## ORIGINATION FORM

Proposed Revisions to a Standard Plans Index  
(Please provide all information — Incomplete forms will be returned)

Index Number: 430-001  
Sheet Number (s): 4 of 7  
Index Title: Miscellaneous Drainage Details

EXTENSION OF EXISTING PIPE CULVERTS

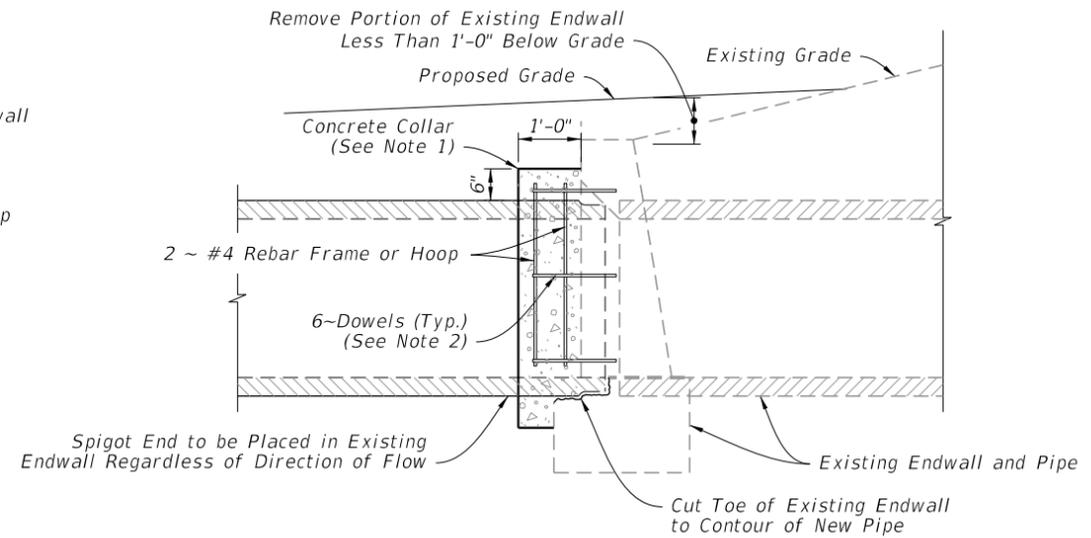
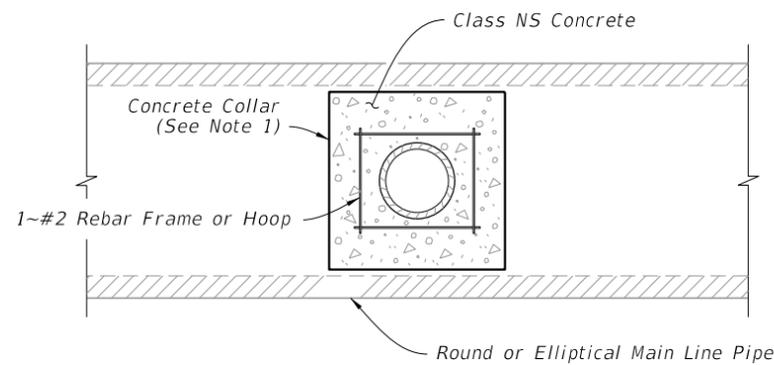
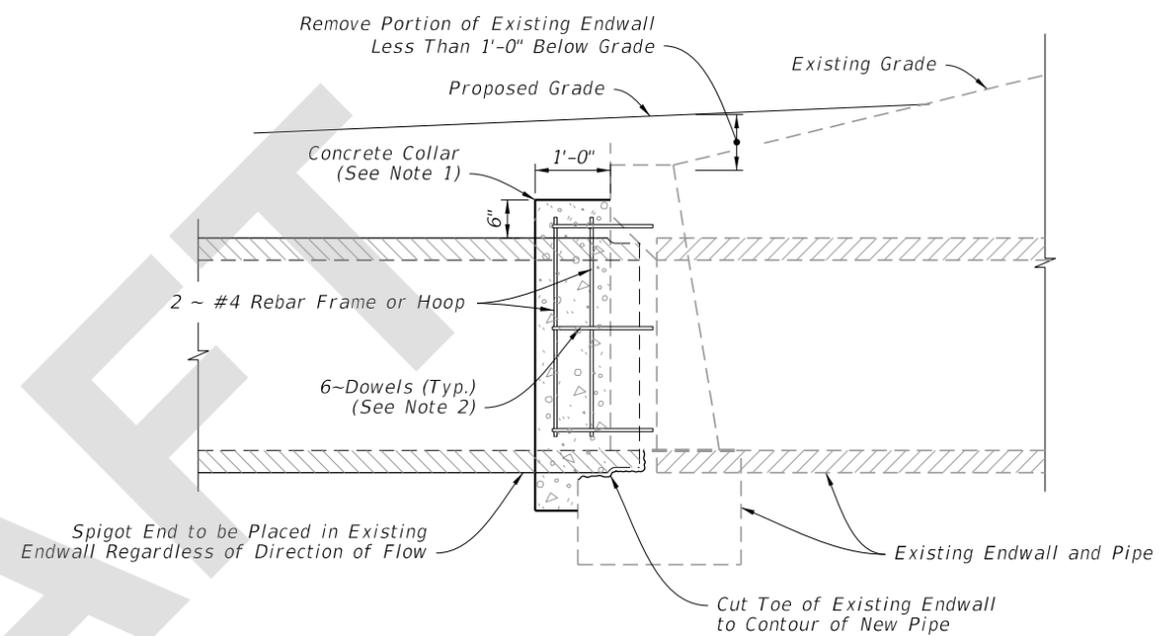
Sheet 4: Moved "Joining Mainline Pipe to Stub Pipe Details" and Notes 2 and 3 to the Standard Plans Instructions:  
Deleted Notes 5-7.

1. The collar may be formed by any method approved by the Engineer.
2. Install 1/2"x16" dowels in adhesive bond material.

JOINING MAINLINE PIPE TO STUB PIPE

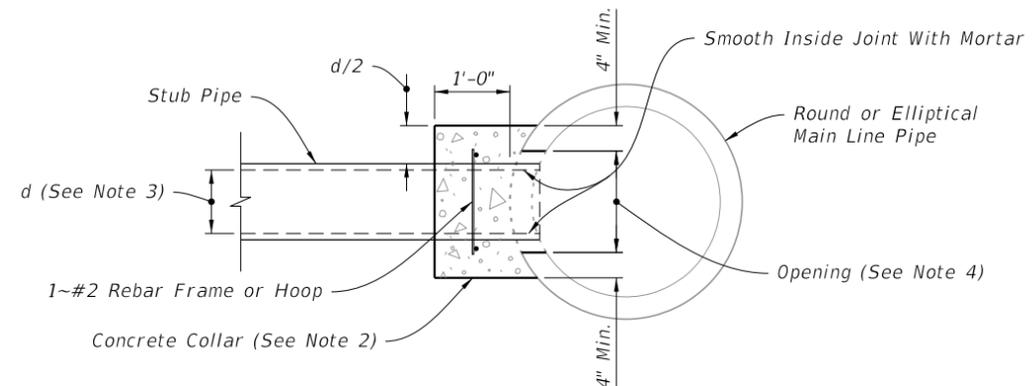
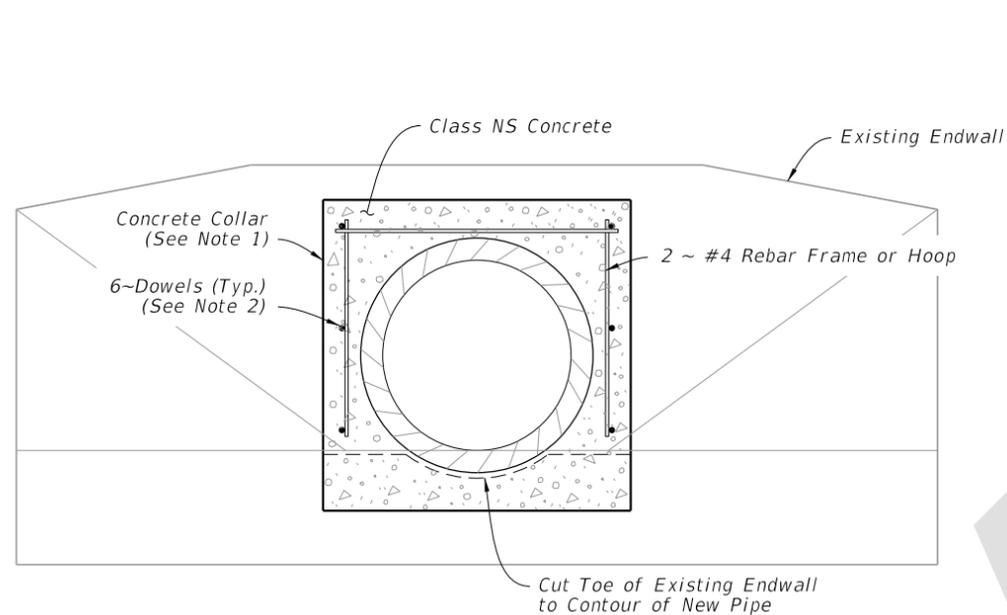
The Drainage Manual requires pipe junctions to have topside access via a structure. Deviation from using a structure to join pipes requires District Drainage Engineer approval. While there are applications where the stub to mainline pipe may be needed, the detail is proposed to be removed from the Index to emphasize it as a non-standard item.

Moved to SPI

- ~~Install riser reinforcement using #5 Bars @ 18" centers vertically and 6" centers horizontally. Bend pipe steel to riser.~~
- ~~Reinforced concrete top required when inlet: manhole or junction box riser is less than 4 feet in diameter; or when 3'-6", alt. b inlet, manhole or junction box riser is used; or when rectangular inlet is used.~~
- ~~See Index 425-001 for optional construction joints.~~

DELETED
